CITY of NOVI CITY COUNCIL

Agenda Item 4
July 23, 2012

SUBJECT: Consideration of the request of Cahen Architectural Group for Preliminary Site Plan, Phasing Plan and Stormwater Management Plan approval for a new retail building, SP12-26. The subject property is located at 44275 Twelve Mile Road, south of Twelve Mile Road and west of Donelson Drive, in the RC, Regional Center District. The subject property is approximately 67.2 acres and the applicant is proposing to add a 57,793 retail building with associated parking and landscaping near the center of the existing Twelve Mile Crossing at Fountain Walk development.

12 Mile Crossing at Fountain Walk - New Retail Building SP12-26

PHASING PLAN

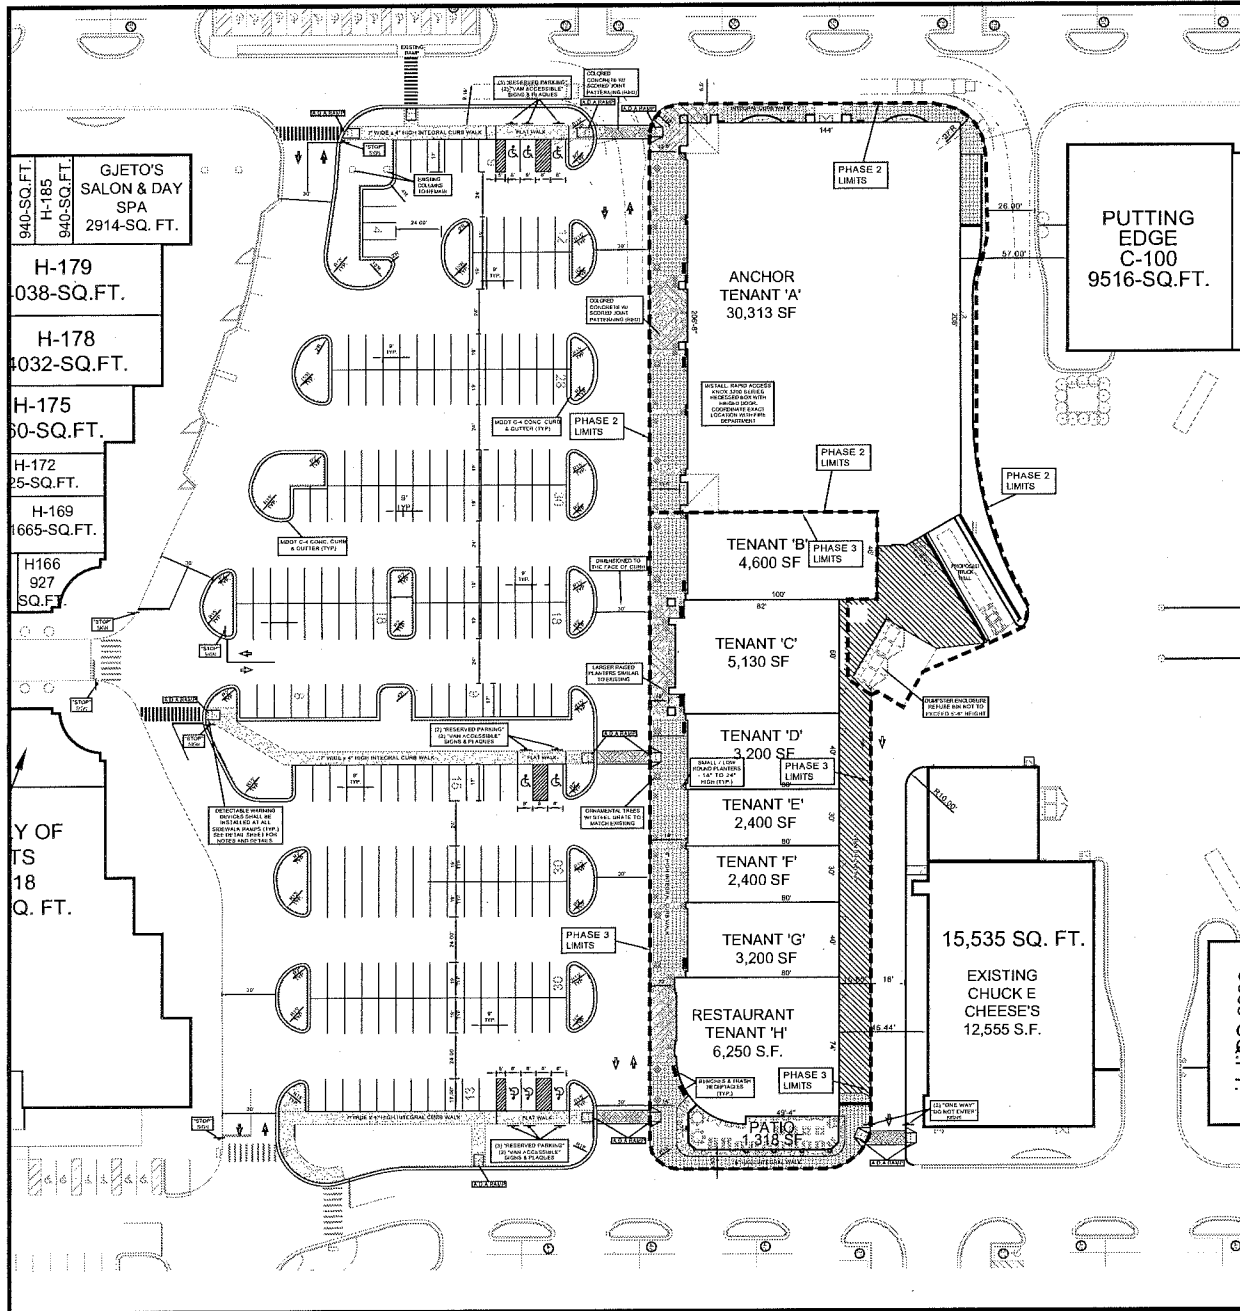
Following staff's review but prior to the Planning Commission meeting, the applicant submitted a phasing plan showing a three phase development. The applicant has proposed the first phase include the installation of all utilities and lighting and the construction of the parking area and building pads. The second phase is proposed to include the larger anchor tenant space and the dumpster and loading area and the third phase would include the remainder of the retail buildings. Staff recommends approval of the proposed phasing plan with the following modifications:

1. All facades of the anchor tenant building identified as Phase 2 must meet the standards of the façade ordinance or any waivers that are granted. The applicant must provide a note on the plans to indicate compliance with this condition;
2. The area identified for Phases 2 and 3 shall be maintained as landscaped greenspace until construction on the respective phases begins;
3. A portion of the pathway totaling at least 5' width and included in Phases 2 and 3 along the proposed building frontages shall be installed with the construction of Phase 1; and
4. Loading zone screening consisting of landscape materials approved by staff shall be installed along the south side of the existing loading zone in the area where Phases 2 and 3 are currently shown within one year of the completion of Phase 1 if construction on Phases 2 and 3 has not begun.

Member Anthony asked if the building footprints would remain greenspace until construction on those phases began.

Member Anthony said so once the parking lot is done with its landscaping, instead of pouring a concrete slab of the footing, they'll hold off on that until they're ready to build the building and then that area will be a grass field or a landscape lawn.

- a. All facades of the anchor tenant building identified as Phase 2 must meet the standards of the façade ordinance or any waivers that are granted. The applicant must provide a note on the plans to indicate compliance with this condition;

- b. The area identified for Phases 2 and 3 shall be maintained as landscaped greenspace until construction on the respective phases begins;
- c. A portion of the pathway totaling at least 5 feet in width and included in Phases 2 and 3 along the proposed building frontages shall be installed with the construction of Phase 1;

- d. Loading zone screening consisting of landscape materials approved by staff shall be installed along the south side of the existing loading zone in the area where Phases 2 and 3 are currently shown within one year of the completion of Phase 1 if construction on Phases 2 and 3 has not begun; and
